COLLINS RADIO COMPANY

30S-1 RF LINEAR AMPLIFIER

SERVICE BULLETIN NO 2

PREVENT INTERMITTENT DROPOUT OF PLATE OVERLOAD RELAY

30S-1 Relay Shelf, Underside, Modification Instructions

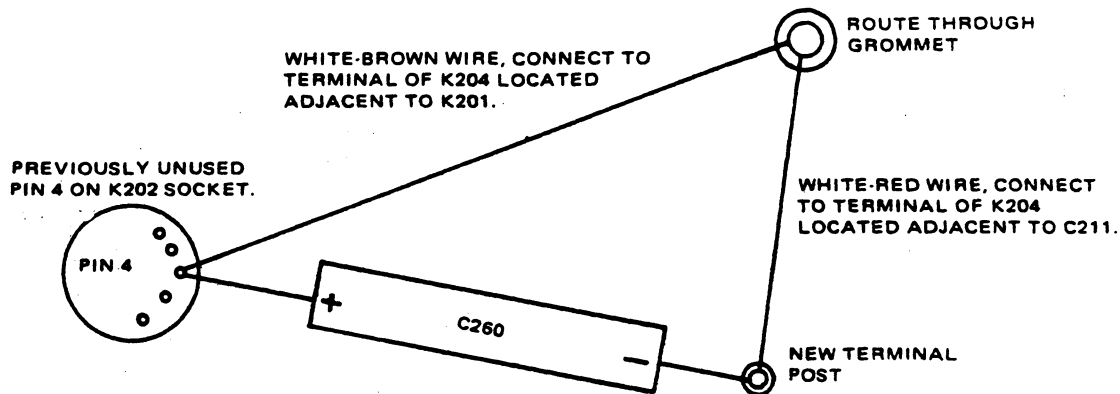
Some 30S-1 operators experience occasional dropout of plate overload relay K204, caused by short duration high plate currents. These currents sometimes occur after application of signal but before the exciter output is reduced by the alc circuits. A 2000- μ F, 6-volt dc capacitor installed across the energizing coil of the relay presents a low-impedance path to the audio envelope currents, but continues to provide dc overload protection. The instantaneous currents are not harmful to the 4CX1000A tube because of conservative tube operation.

To determine if this modification is installed, check for the presence of the tubular electrolytic capacitor visible at the left front underside of the relay shelf.

1. Remove all power to unit and remove relay shelf and position it in a manner to gain access to lower side of shelf. Locate K202 socket and K204 mounting nut on the underside of the relay shelf, and remove mounting nut.
2. Install terminal post (306-0978-000) in place of removed K204 mounting nut.

3. Install 2000- μ F capacitor C260 (183-1311-000) and approximate 10-inch lengths of white-brown (439-7302-000) and white-red (439-7303-000) wires as shown in the illustration.
